**Model** : GP605  
GP555

**Ref. No. :** FF-T01- K1-000035-01

**Location** : SEPARATION MOTOR ASSEMBLY

**Subject** : COUNTERMEASURE FOR DOCUMENT JAMS CAUSED BY DAMAGE TO SPRING,  
TENSION.

Figure

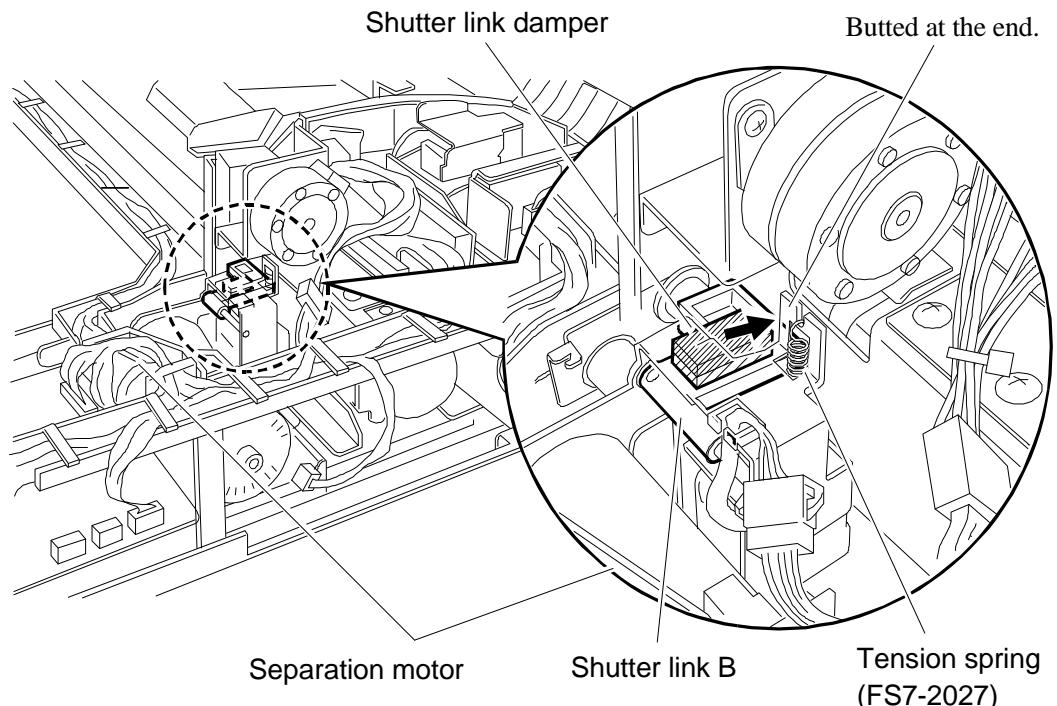
**Reason** : As a countermeasure against document jams, the durability of the tension spring in the ADF separation motor assembly has been increased.

**Details** : <Symptom>  
With older parts, when paper is being fed by the ADF, the document stopper guide sometimes fails to lower properly, causing a document jam.

<Cause>  
The tension spring inside the ADF separation motor assembly gets weaker with age and may snap. This causes the document stopper guide to be unable to lower, resulting in a document jam.

<Factory measure>  
In order to increase the durability of the tension spring in the ADF separation motor assembly, the tension spring has been changed and new parts (shutter link damper) have been added to reduce the load on the spring.

- 1) Remove the ADF outer cover.
- 2) Replace the old tension spring (FS7-2027) at the back of the ADF separation motor assembly with the new tension spring (FS7-2027). (Parts catalogue FY8-31DV-00, page 21-5)
- 3) Peel off the backing tape from the double sided tape and align the shutter link damper (FB4-8068) with the edge of the shutter link B (FB4-7769) and affix it.
- 4) Attach the ADF cover in the reverse order.
